Dart Aerospace Ltd. Tuesday, 8/1/2006 11:31:26 AM User: Kim Johnston **Process Sheet Drawing Name** : INNER FWD SADDLE : CU-DAR001 Dart Helicopters Services Customer **Job Number** : 28080 **Estimate Number** : 11079 Part Number : D5953 : NIA P.O. Number S.O. No. 7 N/A : D5953 REV A **Drawing Number** : 8/1/2006 This Issue : N/A Project Number Prsht Rev. : MACHINED PARTS Type **Drawing Revision** First Issue Material **Previous Run** : 8/31/2006 4 Um: **Due Date** Qty: Written By Checked & Approved By 05-11-29 JLM Comment : Est Rev:E Re-Format **Additional Product** Job Number: Description: Machine Or Operation: Seq. #: 7075-T7351 8.25X7.75X2.5 1.0 D6101007 Comment: Qty.: 4.0000 Each(s) 1.0000 Each(s)/Unit Total: D6101-007(7075-T7351) Size 2.50" x 7.50" X 8.25" (Grain along 7.50") En 06/11/07 2.0 HAAS3 Comment: HAAS CNC VERTICAL MACHINING #3 1-Machine as per folio D5953,Ensure Batch Number is entered 5.1 1328080 2-Machine Keyway PTO E0 06/11/08 3-Deburr & Tumble INSPECT ALL DIM TO DIM SHEET 3.0 Comment: INSPECT ALL DIM TO DIM SHEET SECOND CHECK 4.0 QC8

DART AEROSPACE LTD	Work Order:	28080
Description: Inner Fwd Saddle	Part Number:	D5953
Inspection Dwg: D5953 Rev. A		Page 1 of 1

S

DESIGN	DRAWN BY	DART AEROSPACE LT	
CHECKED	APPROVED	DRAWING NO.	REV. A
2008	BW	D5953 si	HEET 1 OF 1
DATE		TITLE	SCALE
97.05.06		INNER FWD SADDLE

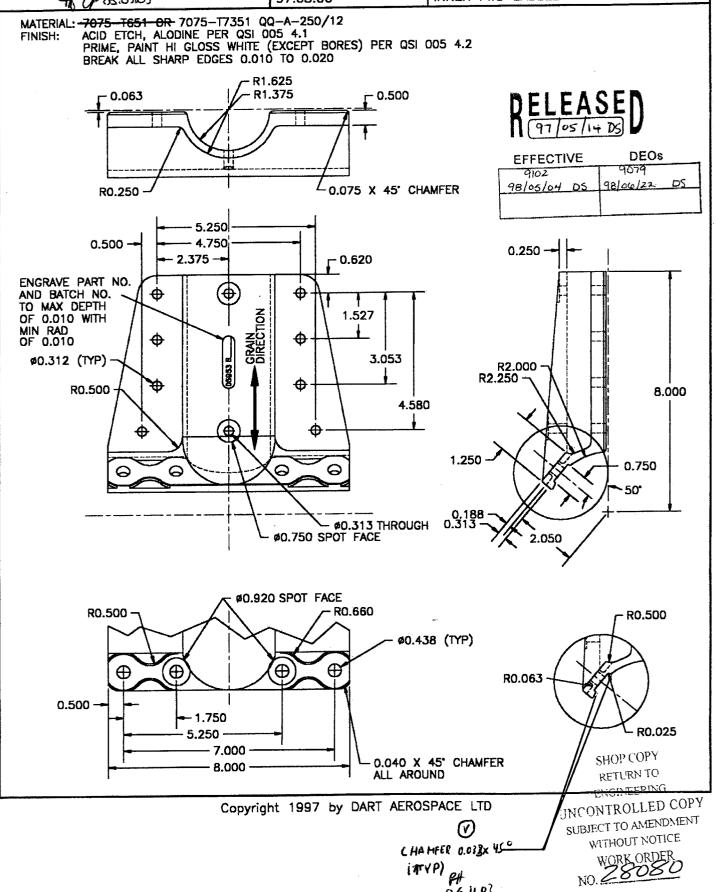
W/O:		WORK ORDER CHANGES								
DATE	STEP	PROCEDURE CHANGE		Ву	Date	Qty	Approval Mfg / Design Mgr	Approval QC Inspector		
05-11-03	2	CHAMFER 0.033 x 45° WAS ADDED AND CALLED	(V). SIMILIAR TO DASFI	PH						
0.0		SEE ATTACHED		80.11.00				06.11.03		
	ļ							06.17.

Last year we made a change to the ridges on the 205 saddles (we made a 0.033" X 45 degree chamfer) which I've attached.

Production is making a run of the extended high gear saddles D5951/D5953/D5955/D5957. Can the changes made to the 205 saddles be applied to the x-tended high gear saddles?

This change is acceptable to me.
